**From:** Barbara Vlamis <barbarav@aqualliance.net>  
**Sent:** Friday, April 19, 2024 9:05 AM  
**To:** Lisa Hunter  
**Cc:** Jim Brobeck; Michael Jackson  
**Subject:** Second comments- Revised Colusa GSP  
**Attachments:** AquAlliance Exhibits Comments on Final Colusa GSP 3.25.2022 (optimized).pdf;  
AquAllianceEtAlCommentsRevisedColusaGSPUpdate2024.pdf

Re: Second Comments on the Revised Colusa Subbasin Groundwater Sustainability Plan

AquAlliance, the California Sportfishing Protection Alliance, and the California Water Impact Network (hereinafter AquAlliance) submit the following comments and questions on the Revised Colusa Subbasin Groundwater Sustainability Plan (“Colusa GSP” or “Plan”). This second set of comments is in addition to what AquAlliance was able to assemble in the two days provided upon the release of the Revised GSP on April 16, 2024 late in the day. These comments were originally submitted to DWR in 2022, but since many of our concerns are still not addressed in 2024, we are sending them to the Colusa Subbasin GSAs now. However, it must be stated that some of the text will be redundant and maybe confusing due to the changes made in the Revised GSP. Because th

Southern Portion of Colusa Subbasin with Subsidence Benchmarks from Figure 4-4 in Final Colusa GSP.

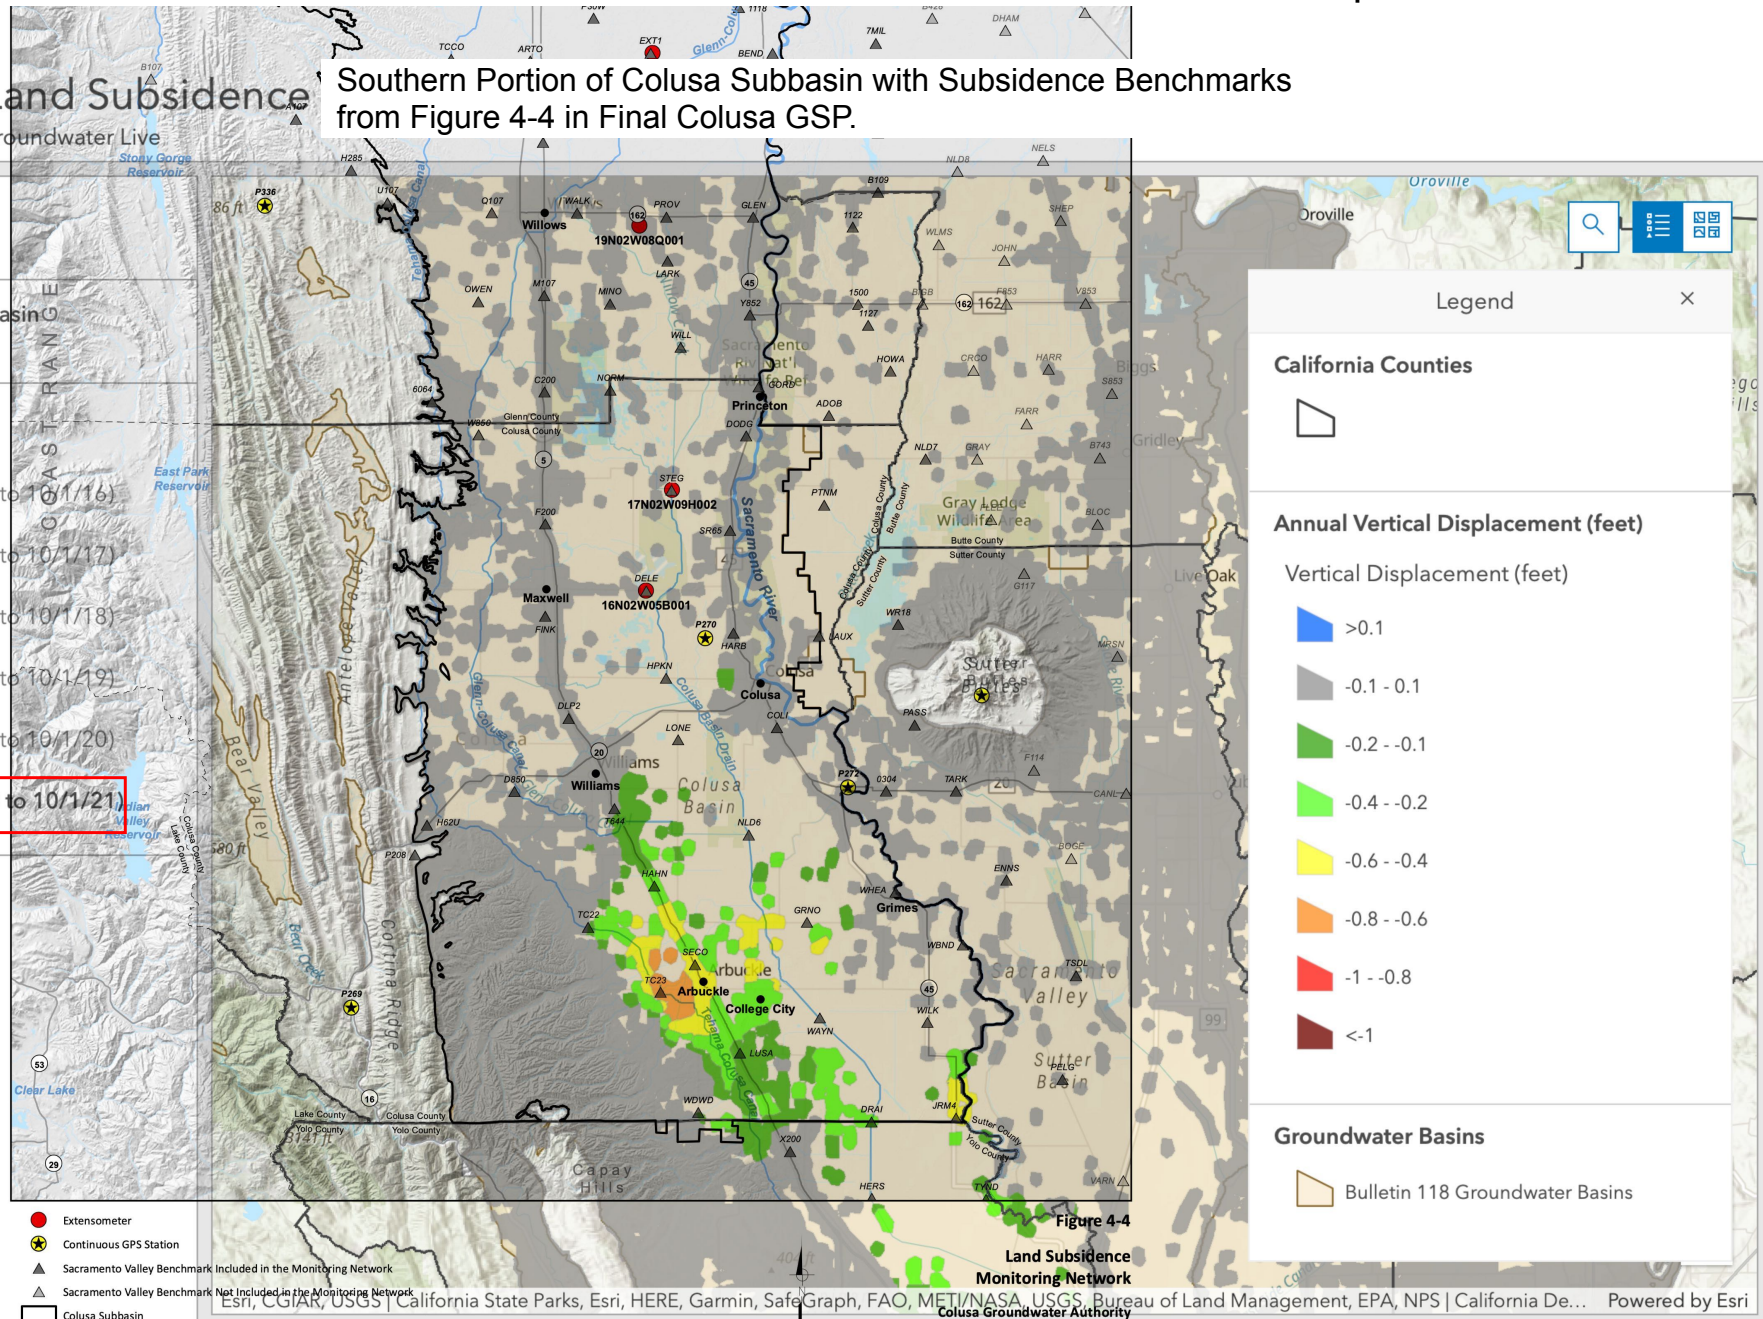
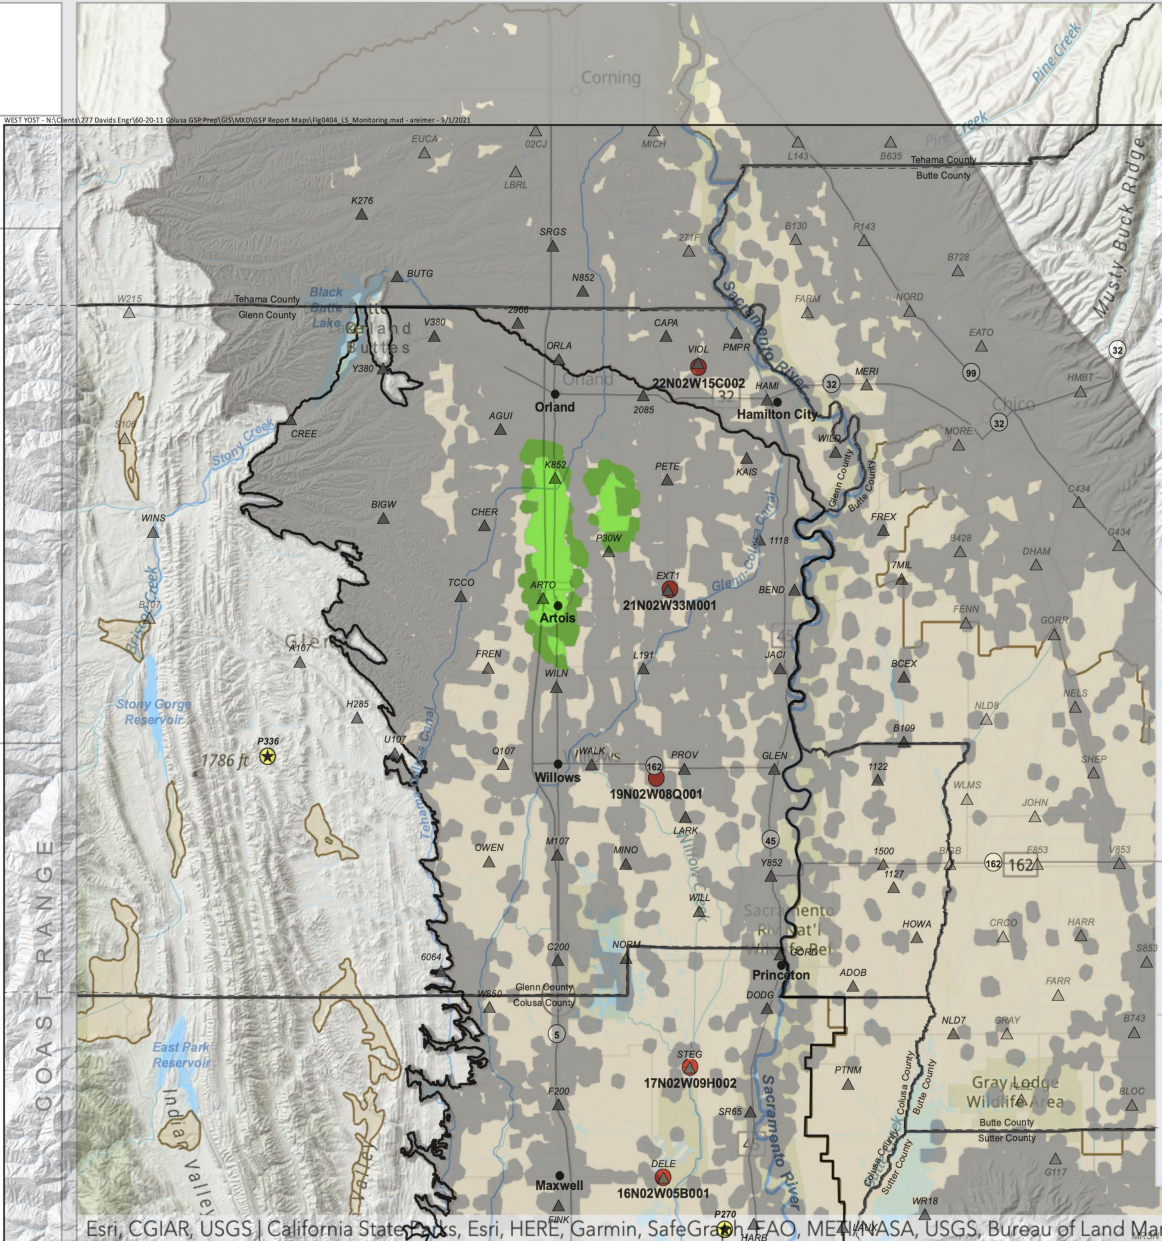
The Colusa GSP needs to provide additional information and reasoning for: (1) why the existing subsidence isn't considered an undesirable result; (2) why the -0.1 feet per year of InSAR vertical displacement shouldn't be considered undesirable; (3) why 20% of the subbasin needs to be in significant subsidence before management actions need to be taken; (4) why subsidence impacts need to be averaged over 5 years when other MT are based on 2 years (24 months); (5) what critical infrastructure has already been harmed by the current areas of subsidence; (6) what amount of additional land subsidence will cause harm to other critical infrastructures; and (7) why the MT for land subsidence doesn't take into account the amount of differential settlement that critical infrastructures and domestic structures in the subbasin can tolerate.
